ASSESSMENT OF PARKING & TRAFFIC IMPACTS ASSOCIATED WITH
SECTION 4.55 APPLICATION
APPROVED MIXED USE DEVELOPMENT
52 – 62 MAY ROAD, NARRAWEENA

This Practice has been engaged by May Road Group / JV Urban to undertake an assessment of the parking and traffic impacts associated with a Section 4.55 Application for alterations to an approved mixed-use development at 52 – 62 May Road, Narraweena.

SCHEDULE OF CHANGES
S4.55 ISSUE

DRAWING TITLE
PLANS - GENERAL ARRANGEMENT BASEMENT 1

DRAWING No
A-0101

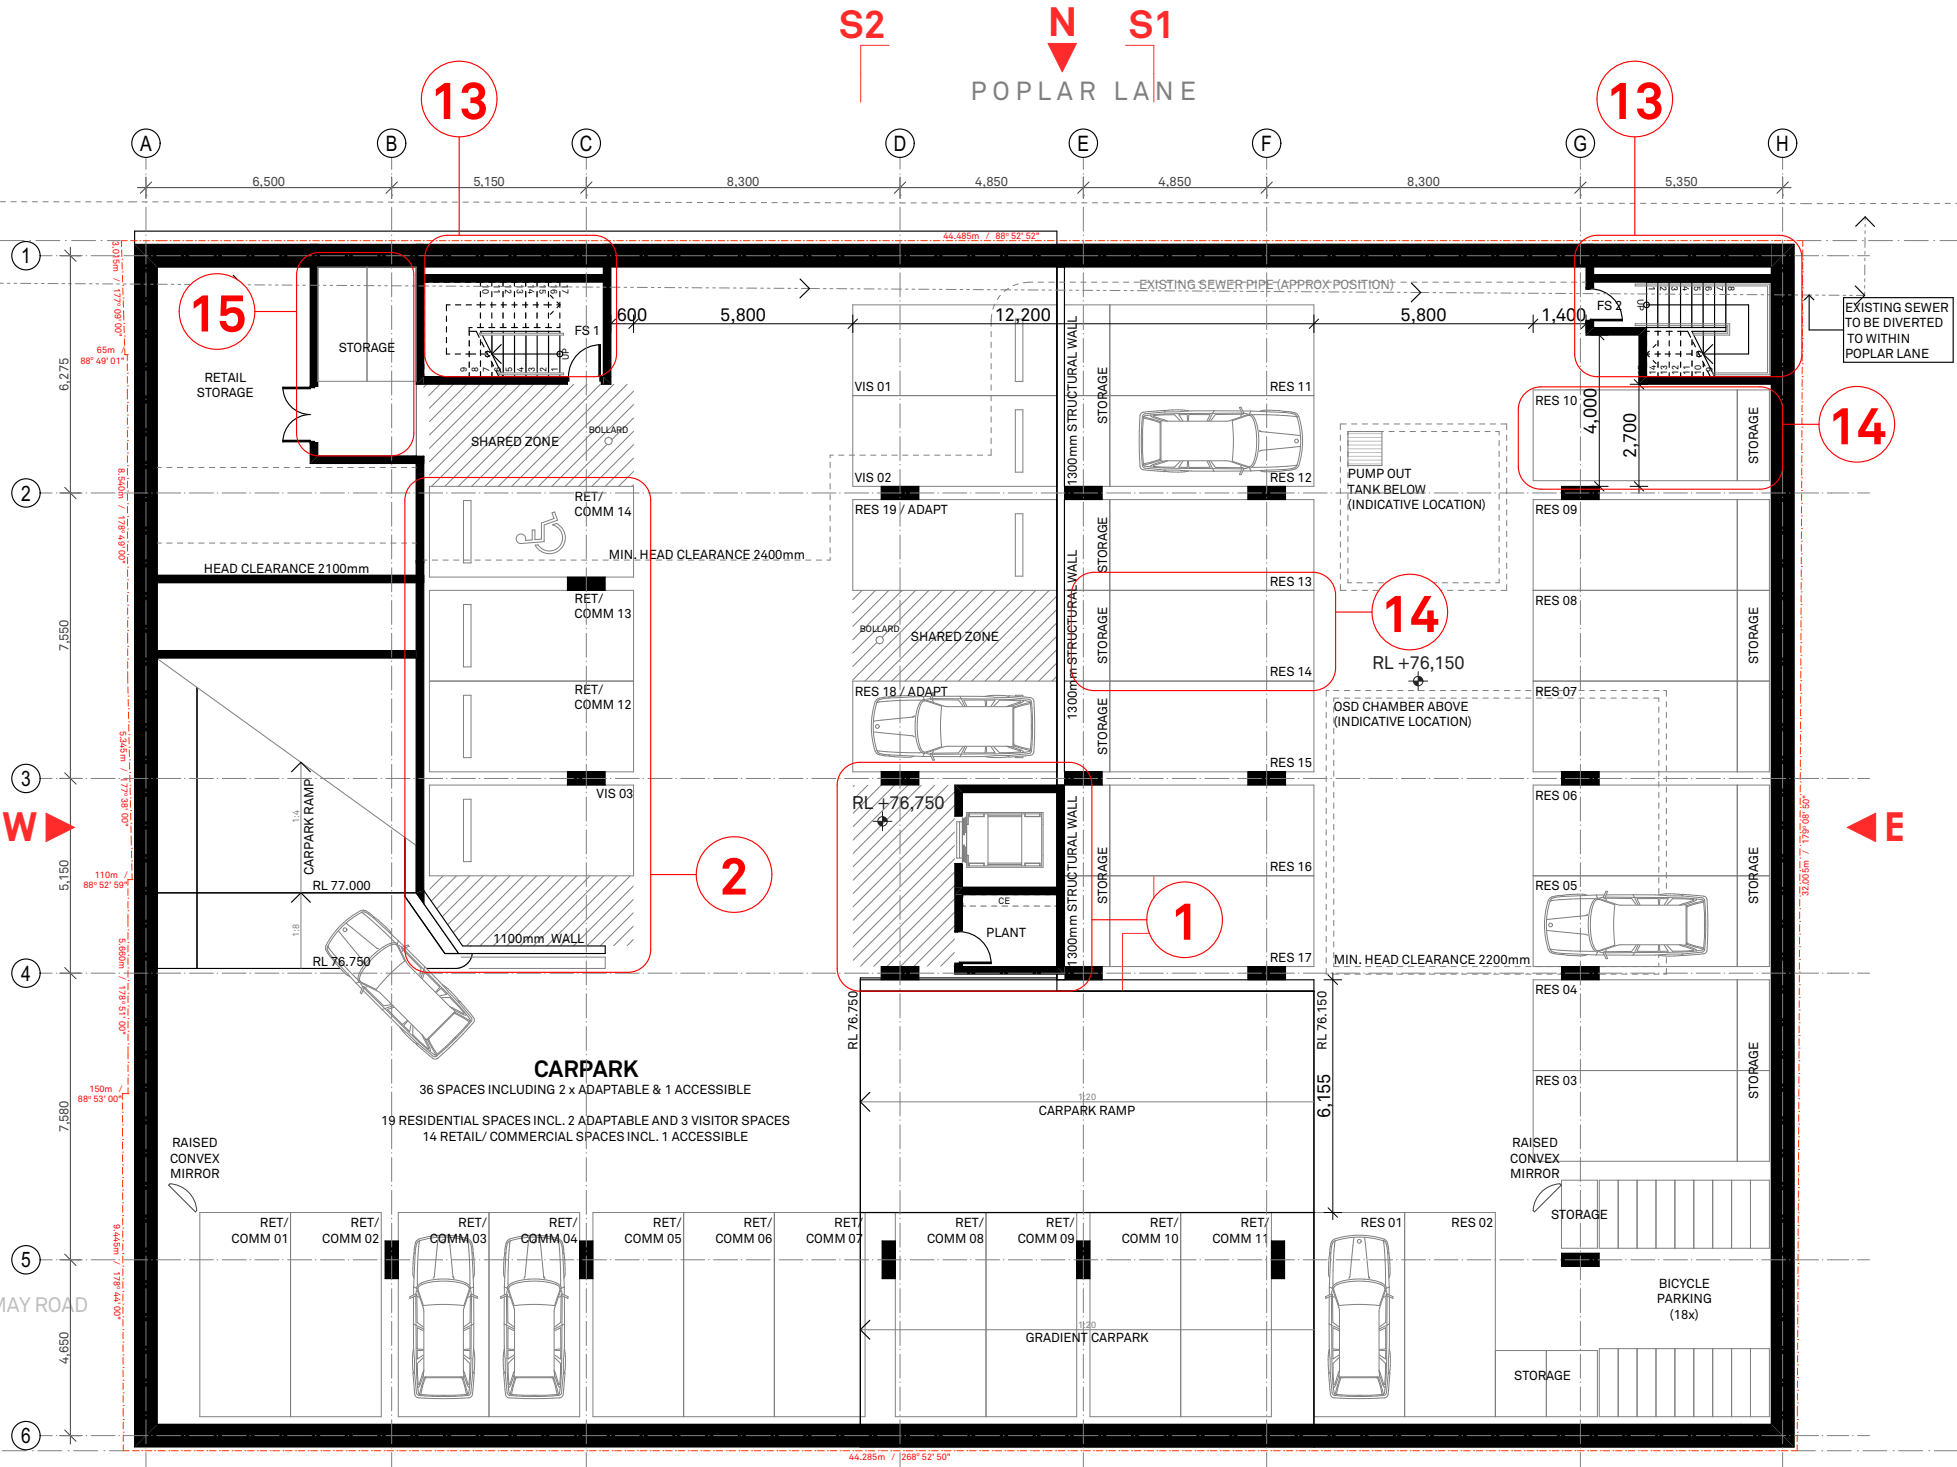
1. Relocation of lift core to the center of the site. Additional storage capacity and plant room.

2. Reconfiguration of carpark layout based on relocation of central lift. Removal of service lift and increased storage capacity.

13. Shifting fire stair 01 and 02 200mm to the north to accommodate for 2 additional car spaces. Stair mirrored and reduction in the length of the southern wall allowing increased swept path into space 10.

15. Relocation of storage spaces to maintain existing total figure of 20

14. Addition of two car spaces achieving a total of 36 parking spaces as per the condition of consent, avoiding the means of a mechanical car stacker.

1. Relocation of the lift core to a more centralised location within the courtyard.

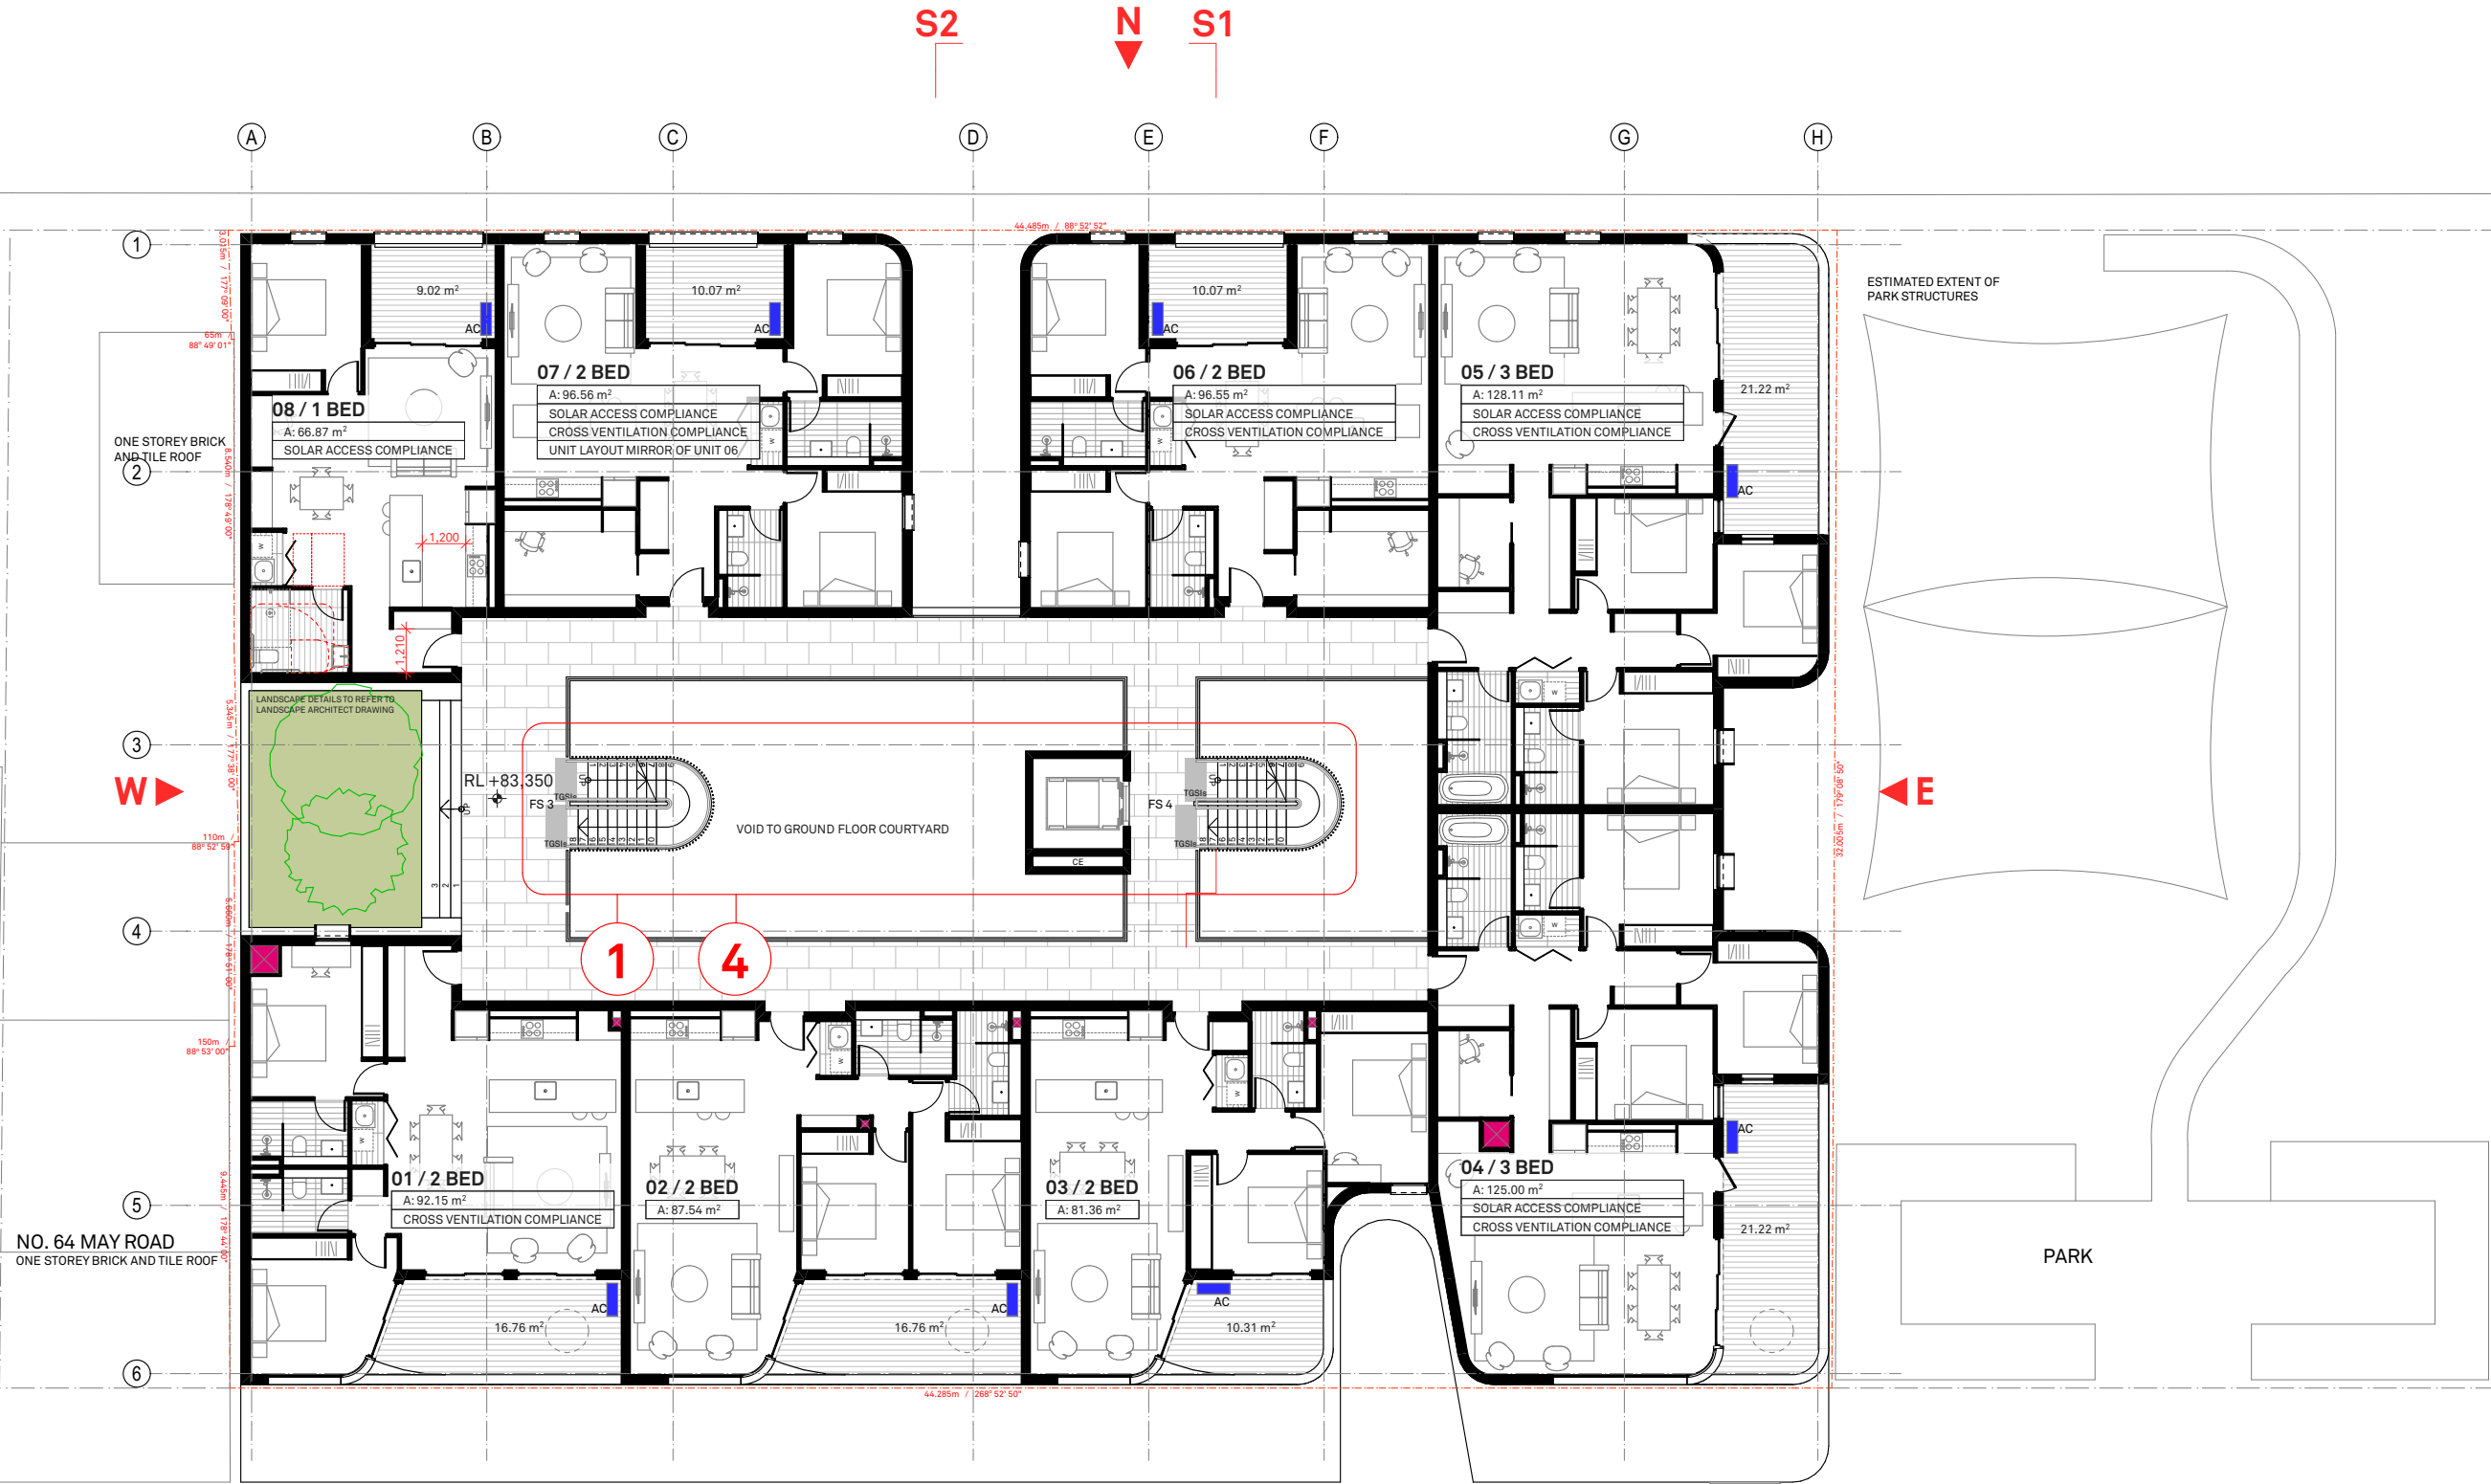
4. Relocation of stairs to be in line with the lift, allowing for a more central circulation path.

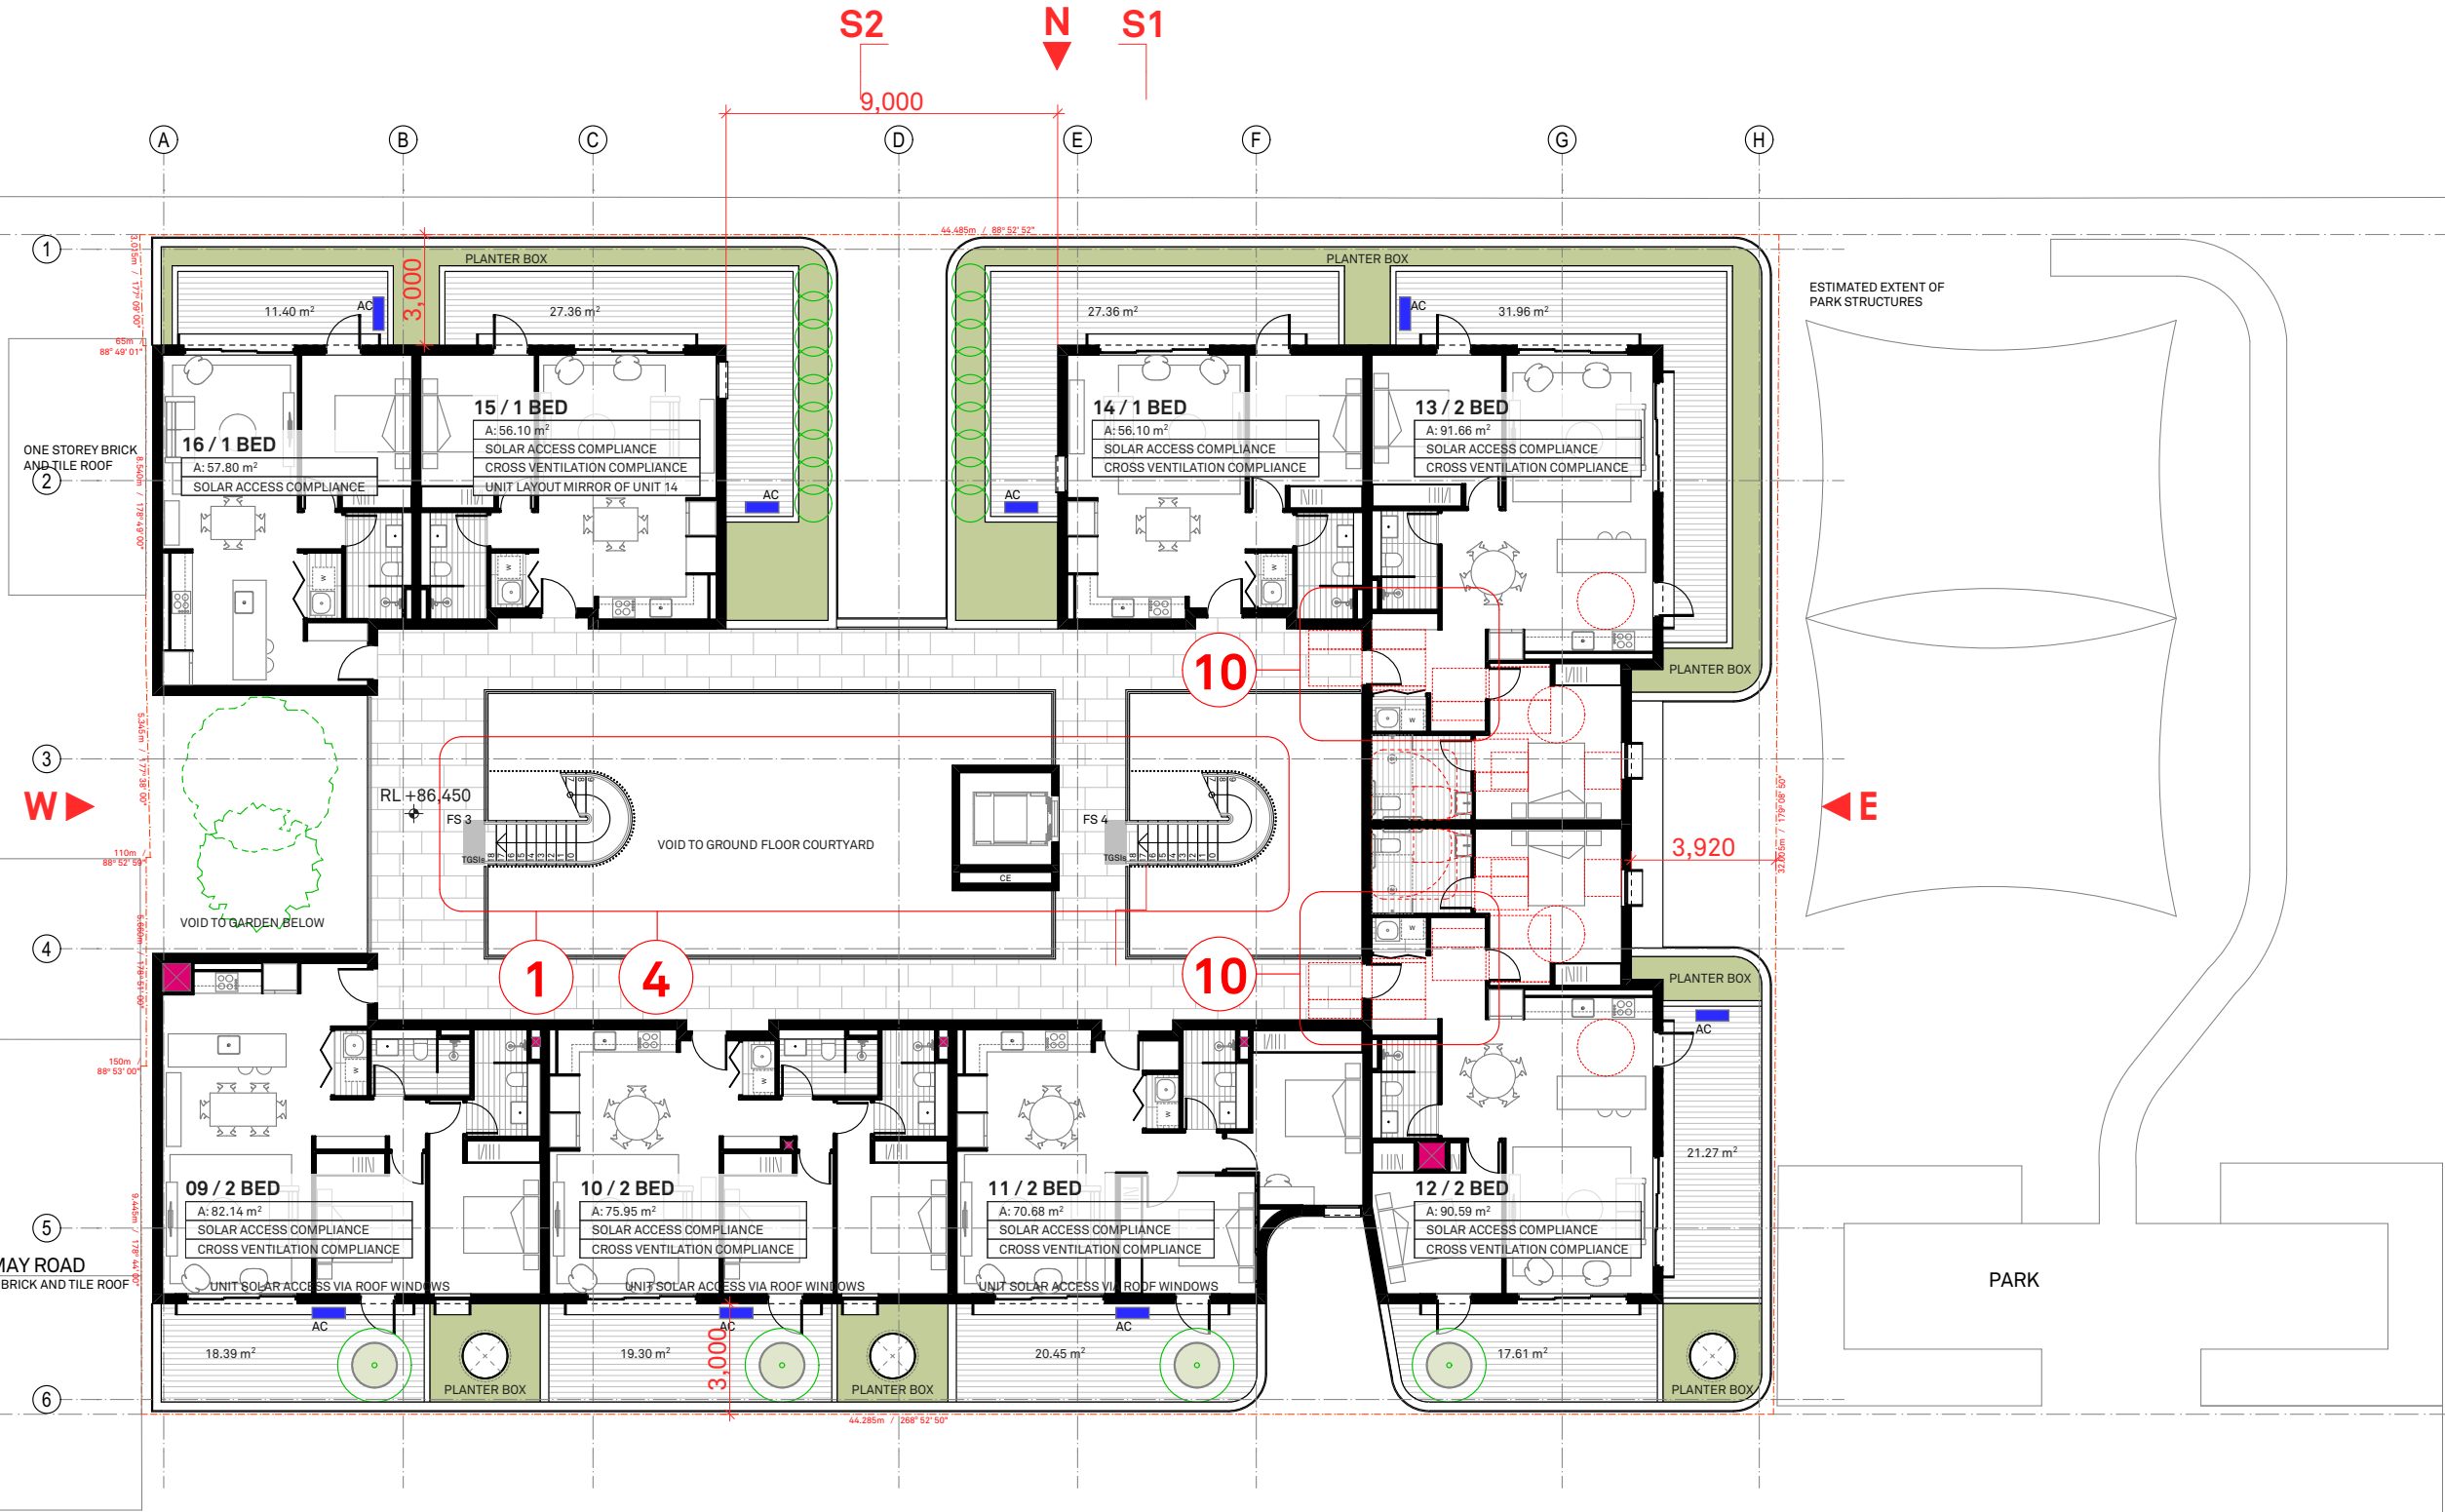
1. Relocation of the lift core to a more centralised location within the courtyard.

4. Relocation of stairs to be in line with the lift, allowing for a more central circulation path.

10. Amendment of entry to unit 12 and 13 addressing reconfigured external circulation path.
